Applicant: Wehler
Application No.: 10/571,880

Remarks

Claims 1 and 14 to 22 are pending in the application, and all were rejected. This application relates to an energy guide chain for a vehicle, and the guide chain has certain bending characteristics that are new and nonobvious. Applicants respectfully submit that the claims are not anticipated and would not have been obvious because there is no disclosure, teaching, motivation or suggestion of the claimed invention in the art of record. Nonetheless, amendments to the claims are made herein to clarify the claims and traverse the rejections. Applicant respectfully requests the withdrawal of the rejections and allowance of the claims.

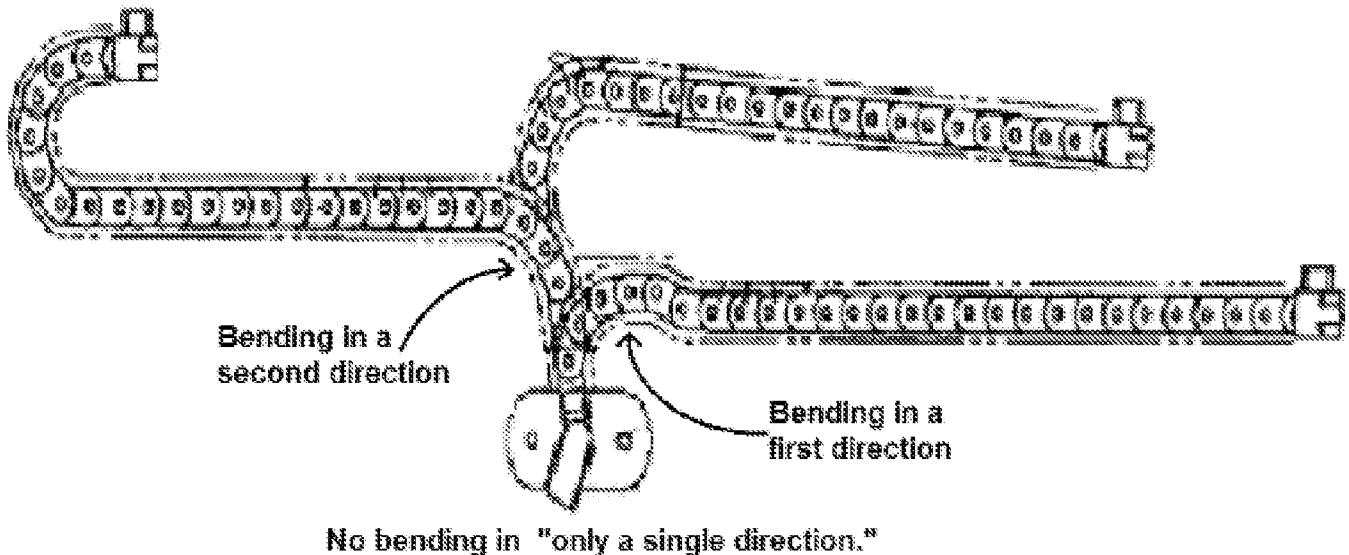
In particular, the amendments more clearly distinguish *Kobayashi et al.*'s disclosure of a chain that has a "second region" (as identified in the examiner's marked-up version of a drawing on page 3 of the action) that bends in two directions. The "second region" is illustrated as bending in two directions, but it appears the examiner may be asserting that the "second region" somehow excludes a bend in an opposite direction. The claims now make clear that the entire energy guide chain between the first end and the second end bends in *only* a single direction. Thus, for this additional reason, the drawing at page 3 of the action is distinguished.

The following is a marked up version *Kobayashi et al.* Fig. 3 to specifically show that the chain of *Kobayashi et al.* bends in a first direction and then in a second direction as the door moves. This is not a disclosure, teaching, motivation or suggestion of the claimed energy guide chain that "bends only in a single direction." Thus, the claims are not anticipated and they would not have been obvious to one of ordinary skill in the art.

Viewing the above figure, there is no doubt that the *Kobayashi et al.* chain bends in two directions. Applicant is unclear how the action can assert otherwise. If the examiner continues to reject the claims by alleging that *Kobayashi et al.* bends in only a single direction, then Applicant respectfully requests a more detailed explanation.
